## **MIDDLE EARTH SUBDIVISION**

Engineering Comments: FINAL PLAT COMMENTS (should be addressed prior to submitting the FINAL PLAT for acceptance and signature by the City Engineer):

APPLICATION NUMBER 2 DATE October 3, 2019

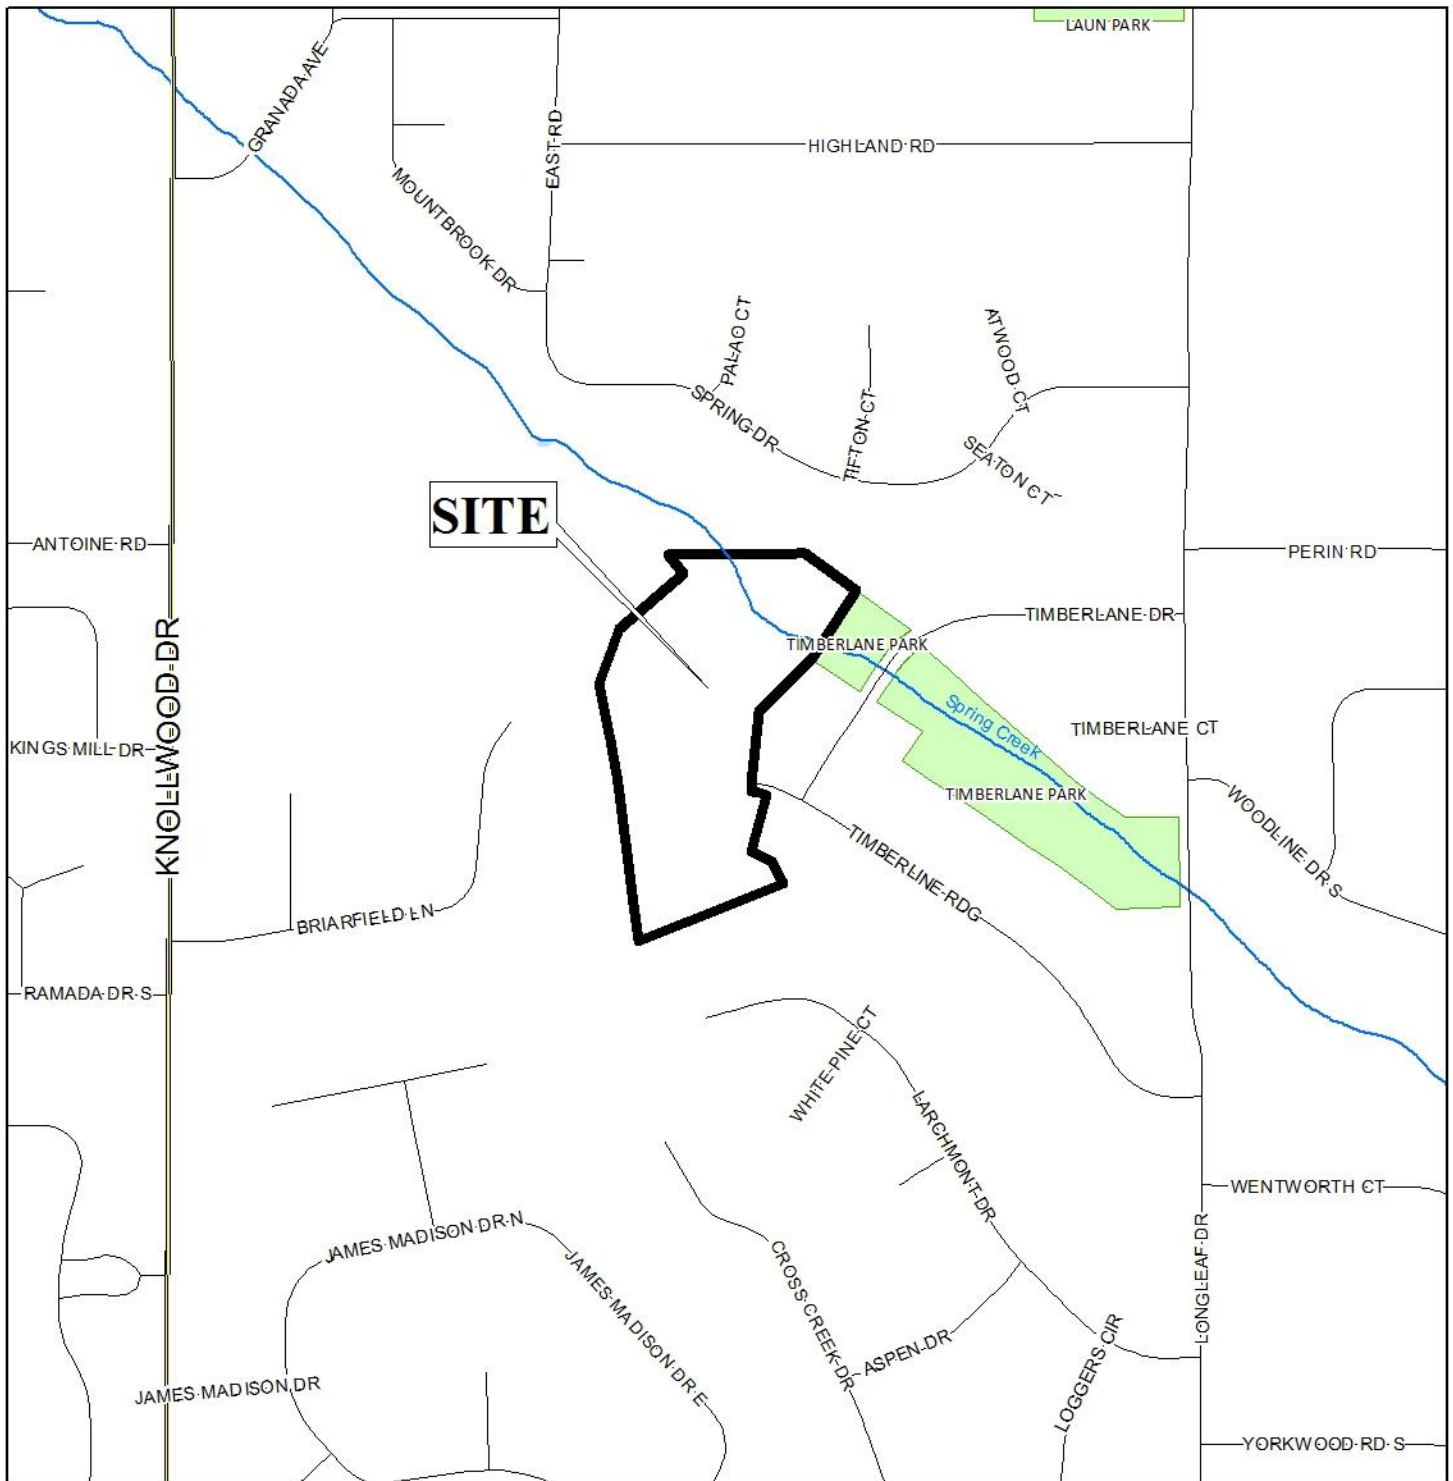
The proposed subdivision has frontage along Timberline Ridge, a minor paved street with curb and gutter; thus a minimum 50 foot right-of-way would typically be required per the Subdivision Regulations. The Preliminary Plat does not illustrate the right-of-way required. Therefore, if approved the Final Plat should be revised to illustrate and provide the 50' right-of-way for Timberline Ridge.

As on the preliminary plat, the lot size information should be retained in both square feet and acres on the Final Plat, or a table should be furnished on the Final Plat providing the same information. A 25' minimum building setback along Timberline Ridge is illustrated and should be retained on the Final Plat, if approved.

- 1) retention of the 25' minimum building setback along Timberline ridge on the Final Plat;
- 2) retention of the lot size in both square feet and acres, or the furnishing of a table on the Final Plat providing the same information;

- 3) placement of a note on the Final Plat stating that no structure may be constructed or placed within any easement (if applicable);
- 4) revision of the Final Plat to illustrate (and if necessary provide) the required 50' right-of-way for Timberline Ridge;
